ITEM 5 (f)

Issue/ Objection:
Visual Impact

REVISION		DATE	DESCRIPTION	BY
		SYDNEY Level 5, 70 King Street Sydney NSW 2000 Australia T +61 2 9251 7077 F +61 2 9251 7072 E fjmt@fjmt.com.au W www.fjmt.com.au		
francis-jones morehen thorp				
NOMINATED ARCHITECT: RICHARD FRANCIS-JONES (REG NO 5301)				
PROJECT				
85 Harrington Street The Rocks GOLDEN AGE & HANNAS THE ROCKS				
TITLE				
CoS Presentation ITEM 5 (f)				
SCALE 1:200 @ A2			PROJECT CODE	
DATE 18/10/2017			GA85H	
SHEET NO.			REVISION	
030

Quay West View Analysis

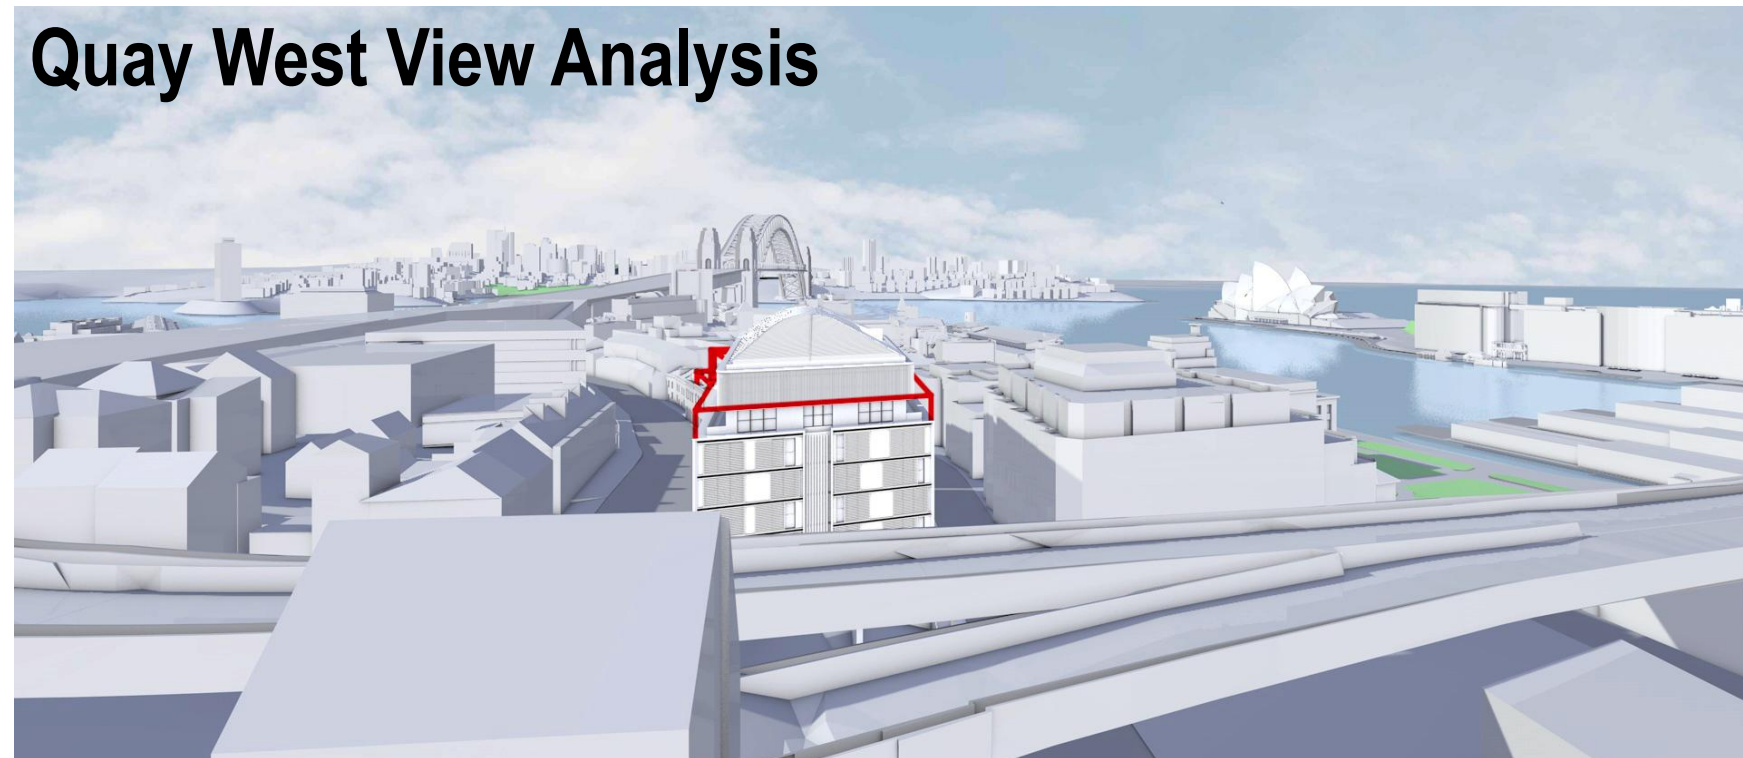
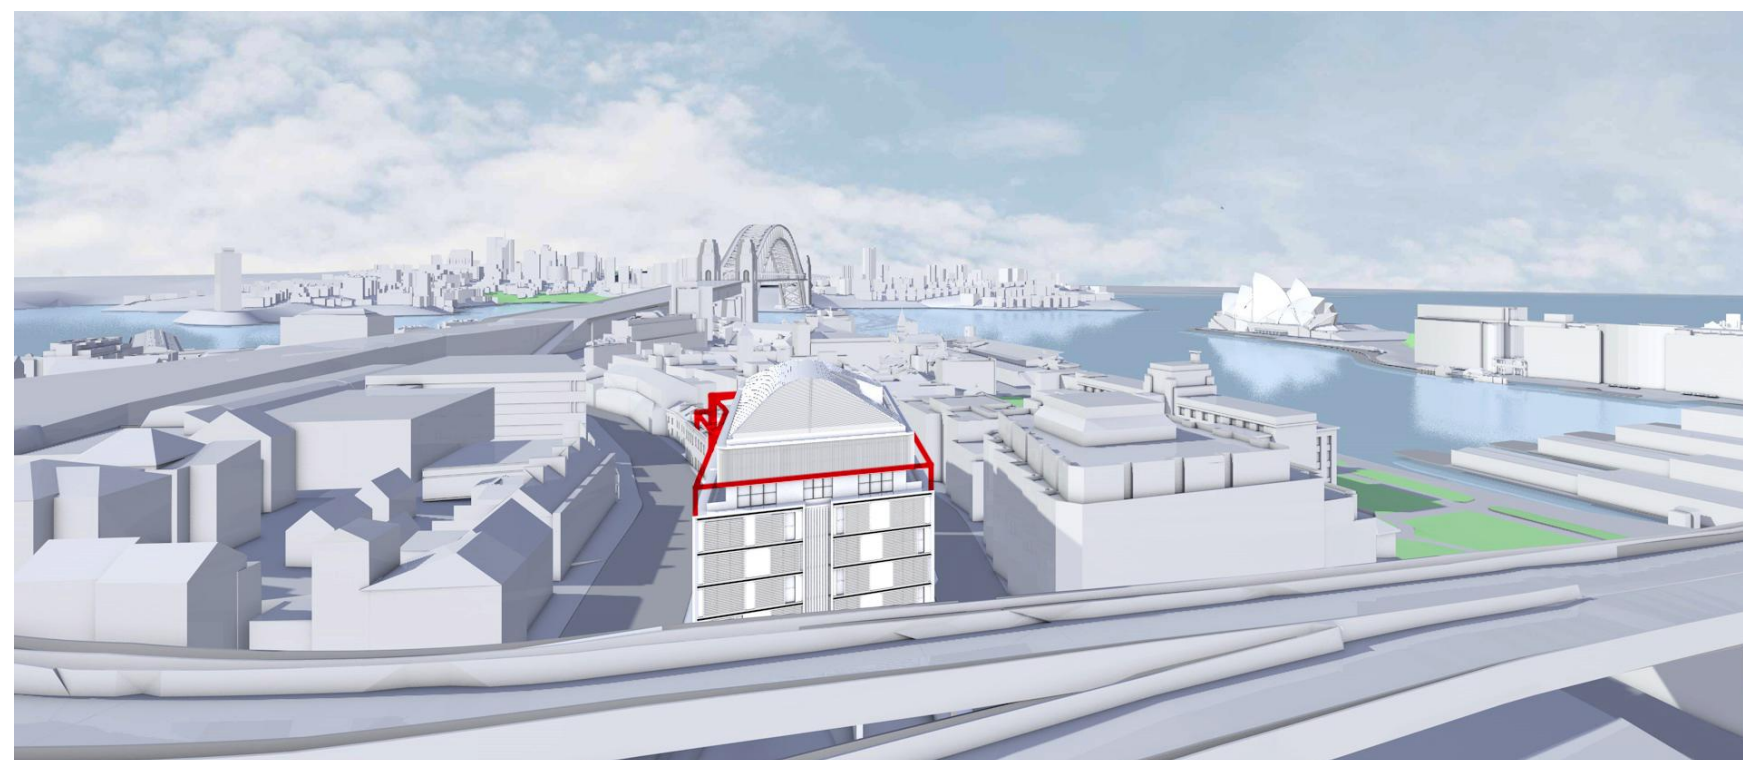
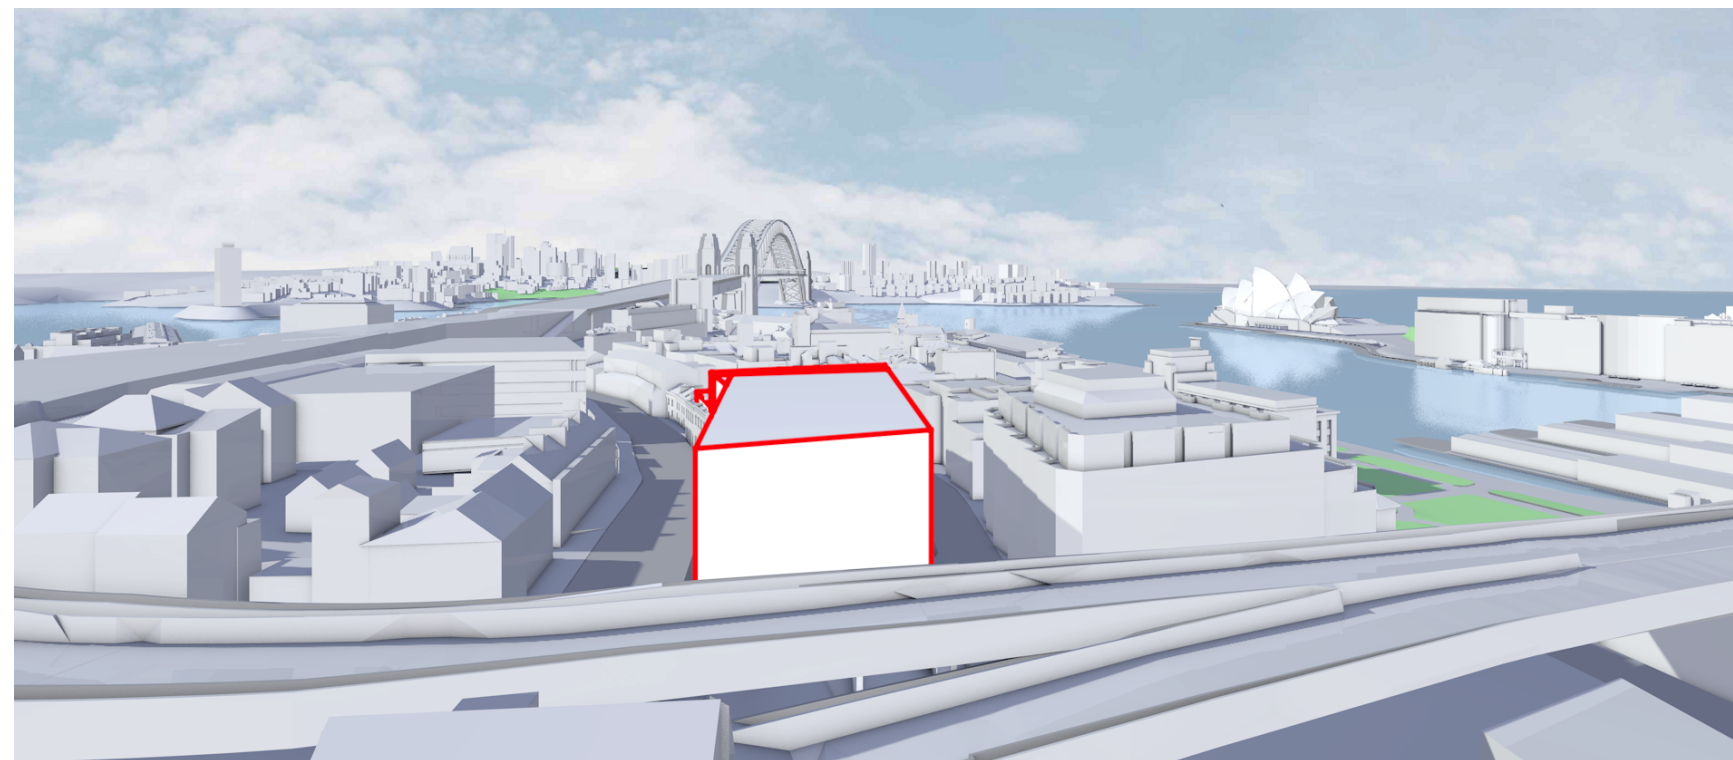
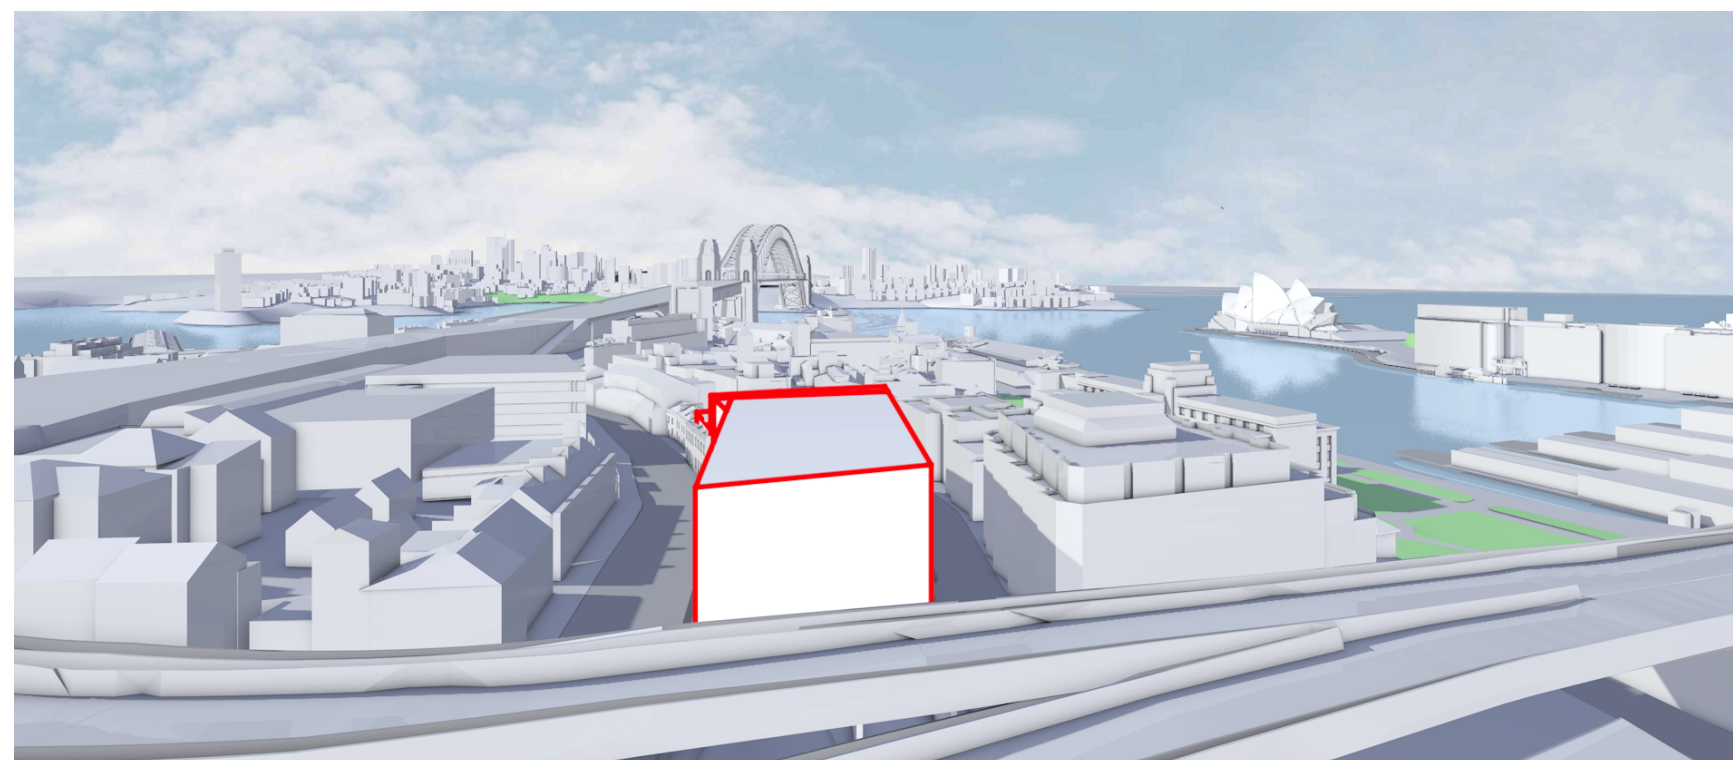
The visual impact analysis submitted with the application fails to accurately identify the visual impact of the proposal as viewed from East Circular Quay and the Opera House and is misleading by stating that the existing development is not visible from these vantage points. The proposal will form a visible backdrop and is likely to detrimentally impact on the significance of the Rocks heritage conservation area. The development would be substantially less visible from these vantage points if it complied with the approved SCRA envelope. An accurate and comparative view loss study should be carried out to determine if the substantial increase of the building envelope has an acceptable level of impact or if a more skilful and modest design could mitigate the visual impacts arising from the proposed building envelope.

As illustrated in our drawings, the proposal has negligible visual impact as viewed from East Circular Quay and the Opera House. Updated diagrams showing impacts from a SCRA compliant scheme and the proposed development have been provided from three surrounding buildings, namely ShangRi La, Quay West and Four Seasons. The images have been enlarged from the originals provided in the submitted DA Design Report. In addition, approximate RLs are included for each of the view analysis.
